## DESIGN INTEGRITY REPORT

849-859 Pacific Highway  
2-8 Wilson Street  
Chatswood

16 October 2024

(RESPONSE TO DESIGN COMPETITION JURY LETTER)

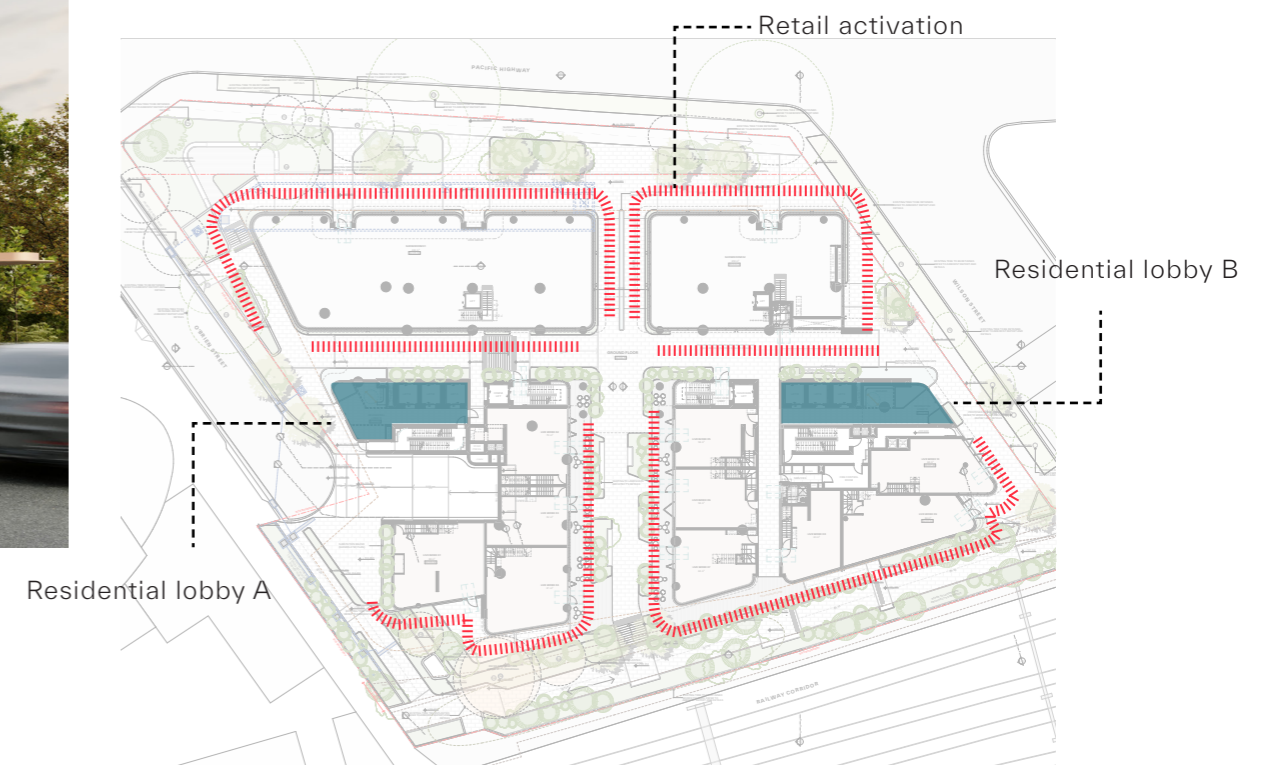
Further consideration and rationalization of the vertical concrete element details/ screen locations to the western facade.

Refined palette for a more subtle hue to reduce the intensity of the rust-red tone.

Architectural language fenestration and consolidation to the southern facade.

Introduction of greater solidity in balustrades to the lower levels for privacy and acoustics.

Other considerations (throw risks)

The 2 vertical breaks on the western facade have been removed and the depth of each vertical concrete elements have been further refined and reduced.

The intensity of the dark rust-red has been refined to include a more subtle palette.

Southern facade expression has been further refined with the inclusion of additional vertical metal elements.

Additional solid upstand have been incorporated to the lower residential levels for additional privacy and acoustic measures.

Balconies within 20m from the rail corridor has been redesigned to reduce throw risks while still ensuring natural ventilation and preserving amenity to the residential units.

Eastern Facade Balcony Treatment - Typical Level  
Solid to void ratio calculation

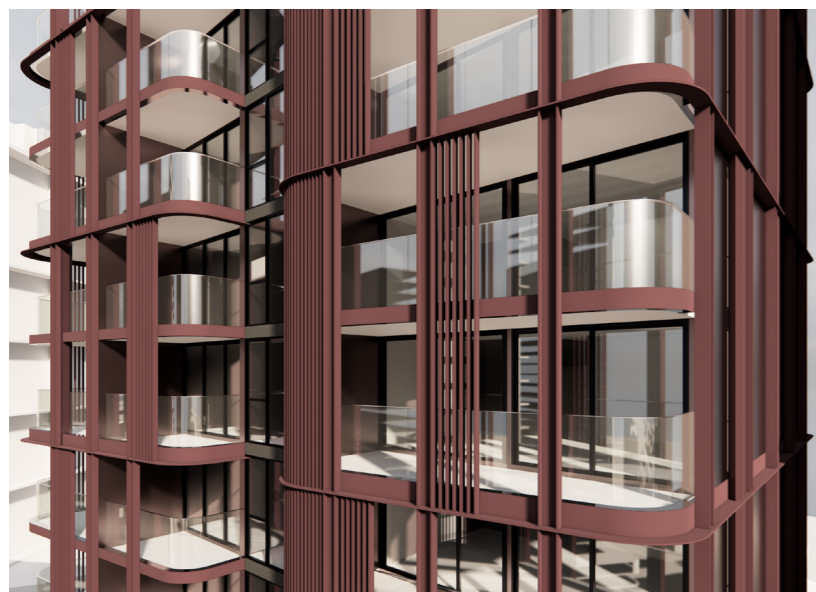
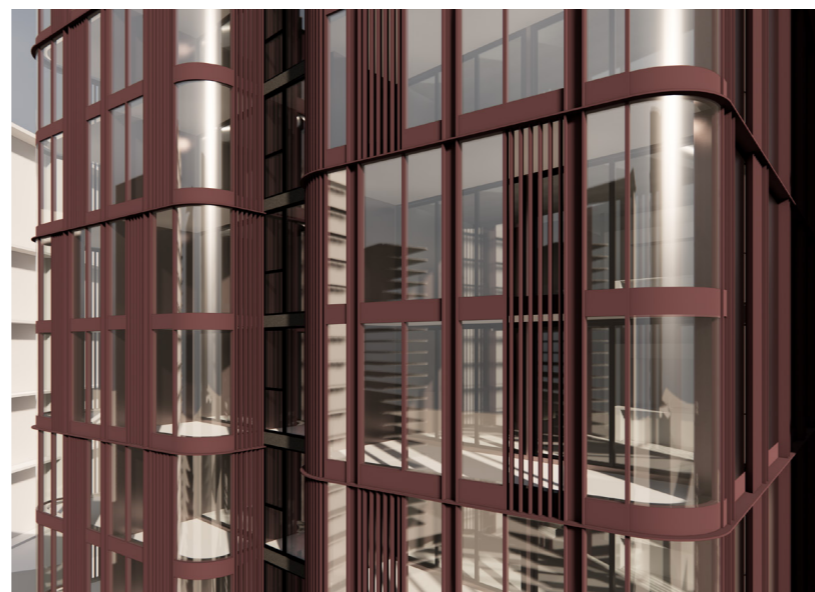
Transport for NSW has established design requirements that outline standards for the interface between developments and rail corridors. Several changes have been made to the design excellence scheme on the eastern and north-eastern facades to comply with these requirements.

On these facades, within 20 meters of the rail corridor boundary, balconies now feature a combination of full-height fixed glazing, vertical aluminium louvers, and horizontal glass louvers (to the podium levels). This design approach adheres to the standards by limiting the maximum opening sizes to minimize potential throw risks to the rail corridor, whilst providing a substantial fixed open component, to prevent full enclosure of any balconies and maintain natural ventilation. Additionally, childcare and rooftop open spaces on the eastern facade include 1.8-meter-high glass balustrades.

These changes have been carefully implemented to comply with the guidelines while maintaining the original design intent of the excellence scheme.
